Submittal via email to [ndpsc@nd.gov](mailto:ndpsc@nd.gov)  
Case Number: PU-14-105

Re: Sunflower Wind Project – Construction Site Access Road Adjustment

## **Attachment 1 - Turbine 28 Access Road Re-route**

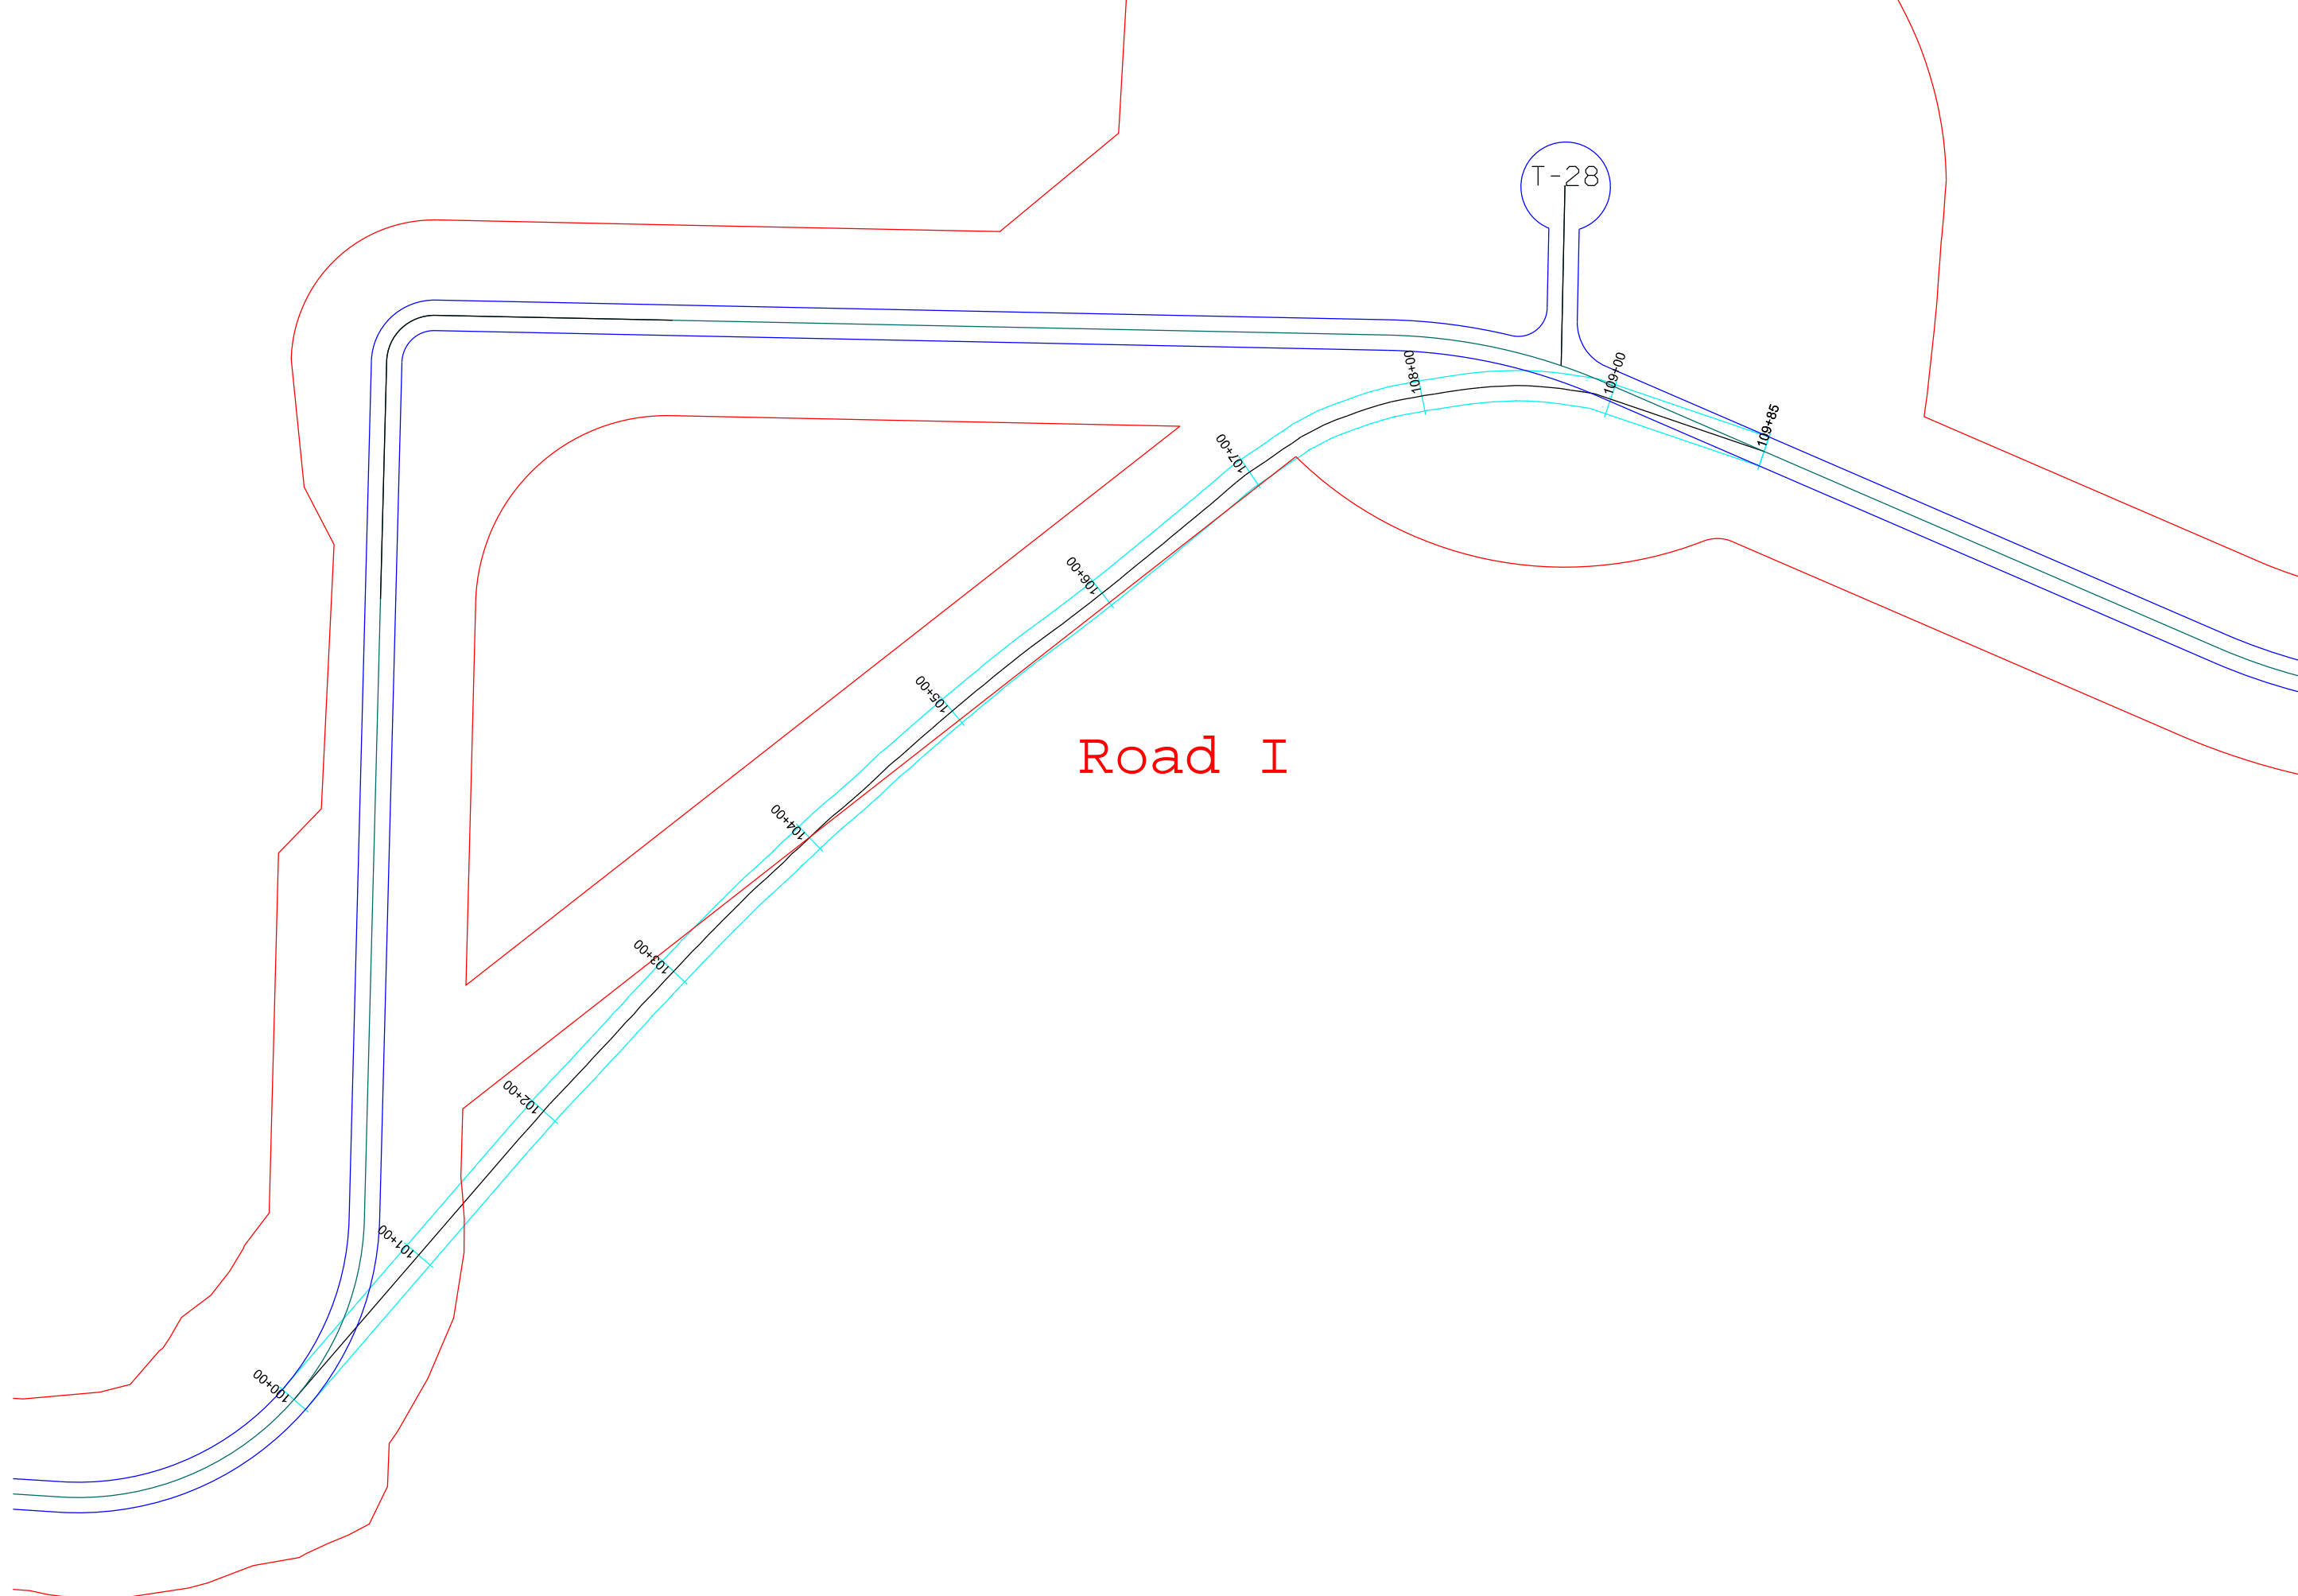
1. Reroute the access road leaving turbine site 28 to follow the collection system routing on higher ground rather than making the 90-degree bend into the low lying area (Attachment 1). This change has been approved by the landowner, remains within the culturally surveyed corridor and will not affect any exclusionary or avoidance areas.
2. Reroute the access road approaching turbine 39 to border the existing fence line rather than removing a portion of the existing fence (Attachment 2). This change is within the leased disturbance area, remains within the culturally surveyed corridor and will not affect any exclusionary or avoidance areas.
